# INITIAL FIRE SAFETY INSPECTION REPORT

**RGR Sweater Ltd. (Extension 2)**

**RSC ID: 26205**

**Date: 16-April-2025**

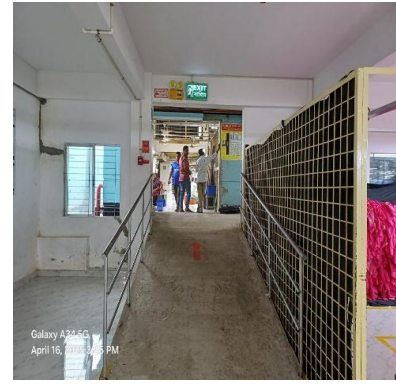
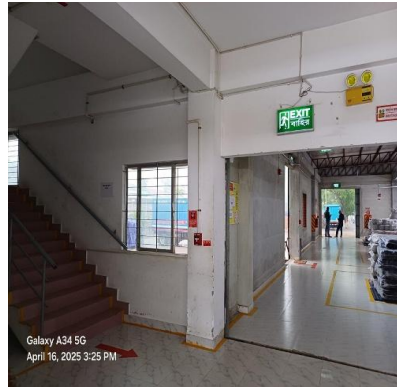
SI No.	Category	Findings	Required Action	Remediation Time Frame
F-1	Means of Egress	<p>The exit stair enclosures are not separated from work areas and other spaces on each floor by fire-rated construction.</p> <p><b>Location: Linking Building</b></p>	<p>The exit stair enclosure shall be provided with a minimum 1-hr fire resistance rating for buildings with 3 or fewer stories and a minimum of 2- hr. fire resistance rating for buildings 4 or more stories. Provide 1-hr. fire rated door and seal all penetrations and openings by 1 hr. fire rated fire rated barrier construction for building with 3 or fewer stories. Provide 1.5 hr. fire rated door and seal all penetrations and openings by 2 hr. fire rated fire rated barrier construction for building with 4 or more stories in accordance with section 6.3.1.2 of RSC Technical Guidelines (Standard)<sup>1</sup> V1.0.</p> <p>Provide a fire-resistive rated assembly between the exterior exit stairs and the building up to 10 ft. beyond the end of the stair to achieve the required separation. The rated assembly shall be approved and/or designed by a qualified fire protection engineer.</p> <p>Ensure that the fire doors are self-closing and positive latching and that they are provided with fire exit (panic) hardware where serving production floors. If fire doors are required to be held open for functional reasons, provide automatic closing devices tied to the fire alarm system.</p>	Within 3 months

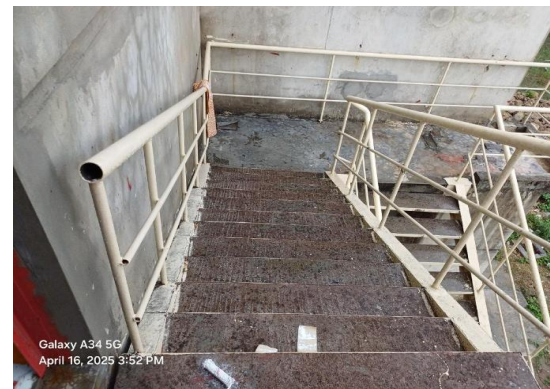
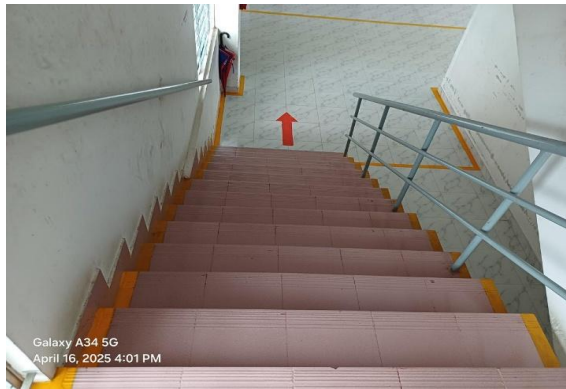
F-2	Mean of Egress	<p>Storage areas discharges directly into the exit stair enclosure.</p> <p><b>Location: 1st floor, Linking Building</b></p>	<p>Openings from exit enclosure to Storage areas/ basements/ transformer rooms/ generator rooms/ boiler rooms and similar normally unoccupied spaces shall be provided with a vestibule with fire rated construction and openings in accordance with section 6.14.3 of RSC Technical Guidelines (Standard)<sup>1</sup> V1.0. . Provide a 1.5 hr. fire rated door on the exit stair side and a 1-hr. fire rated door on the Store, generator, sub-station room side . Ensure that the fire rating of the vestibule construction matches that of the exit stair enclosure as per RSC Technical Guidelines (Standard)<sup>1</sup> V1.0. section 6.14.3. The minimum width for vestibules shall not be less than 1.1m and length 1.8m.</p>	Within 3 months

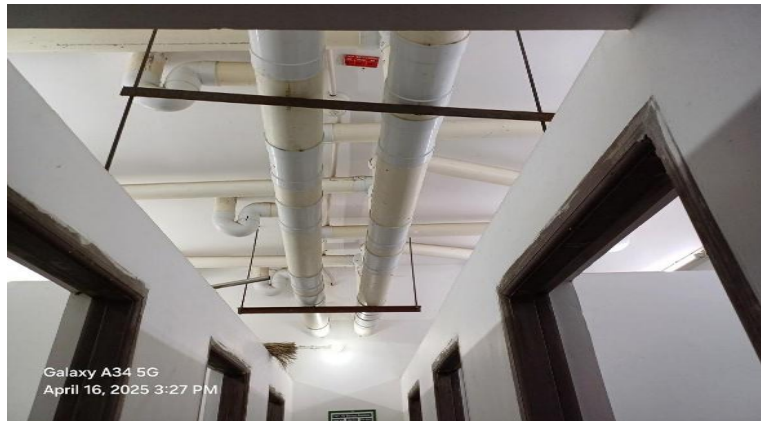
F-3	Mean of Egress	<p>East stair, southeast &amp; southwest exit terminate the occupants in interior of the Linking Building, Yarn Distribution Part-2 &amp; Linking shed which is not in accordance with section 6.17 of RSC Technical Guidelines (Standard)<sup>1</sup> V1.0.</p> <p><b>Location: Ground floor, Linking Building.</b></p>	<p>1. Modify stair to discharge directly outside. Or</p> <p>2. A maximum of 50 percent of the number and capacity of the exit enclosures can discharge through areas on the level of exit discharge where all of the following are met:</p> <p>(1) Automatic sprinkler protection is provided throughout the level of exit discharge or portion of the level of discharge where separated from non sprinklered portions of the floor by fire barriers with the same fire resistance rating as the exit enclosure.</p> <p>(2) The interior discharge is not through a storage or hazardous occupancy.</p> <p>(3) The entire area of the level of exit discharge is separated from areas below by construction having a fire resistance rating not less than that required for the exit enclosure.</p> <p>(4) The way to the exterior shall be free and unobstructed and shall be readily visible and identifiable from the point of discharge of the interior exit.</p>	Within 3 months

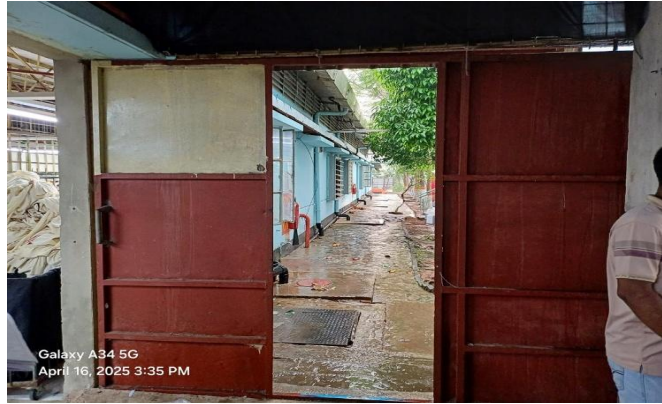
F-4	Mean of Egress	<p>Stair clear width was found less than 60 inch. (East Stair &amp; West Stair clearance width 53 &amp; 45 inch).</p> <p><b>Location: Linking Building.</b></p>	<p>Stairs shall have a minimum clear width of 60 inch for all industrial occupancies as per RSC Technical Guideline (Standard) section of 6.5.6</p>	<p>Within 3 months</p>
-----	----------------	---	---	------------------------

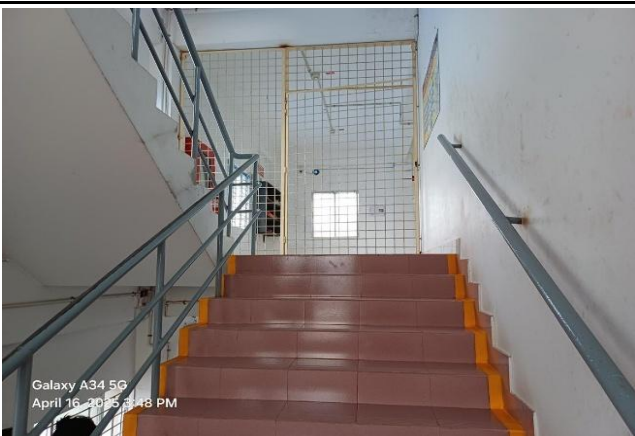
F-5	Fire Rated Construction	<p>Penetrations through floor/ceiling assemblies are found unsealed due to pvc plumbing pipe.</p> <p><b>Location: Ground floor, Linking Building.</b></p>	<p>Seal all penetrations and openings in floor/ceiling assemblies by a listed through-penetration fire stop system tested in accordance with ASTM E814 or approved alternative standard to maintain minimum 2-hr. fire resistance rating. Installation shall be as per manufacturer published installation guideline and the certification authority guideline to ensure the fire-rating in accordance with section 4.7 of RSC Technical Guideline (Standard)</p> <p>Or,</p> <p>Provide a minimum 2-hr fire rated shaft to separate the penetration from each floor if required.</p>	Within 3 months
-----	-------------------------	---	--	-----------------

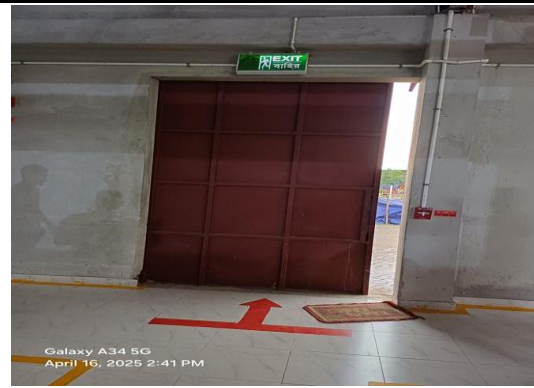
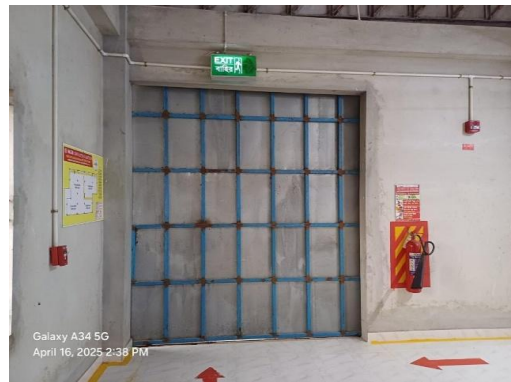
F-10	Fire Rated Construction	The required fire separation distance of Linking Building does not comply with the requirements of BNBC 2020.	The exterior walls shall have a fire resistance and opening protection as specified in BNBC 2020 Part 3 Table 3.2.2 & 3.2.3 and BNBC 2020 Part 3 Section 2.4.1.3.	Within 6 months

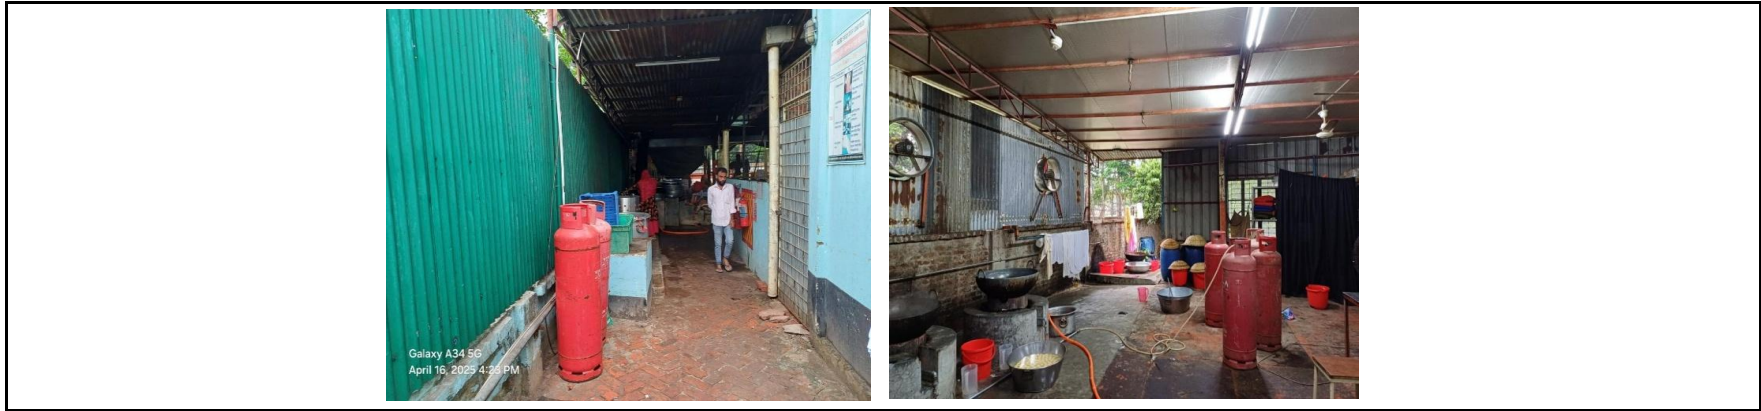
F-13	Mean of Egress	<p>Non compliant sliding door has been found at north &amp; east exit.</p> <p><b>Location: Yarn Distribution Part-2</b></p>	<p>All doors in a means of egress shall be of the side-hinged swinging type. Roll-down and sliding gates and shutters shall not be allowed. Doors serving an occupant load of more than 50 shall swing in the direction of egress travel.</p>	Within 1 month
------	----------------	---	---	----------------
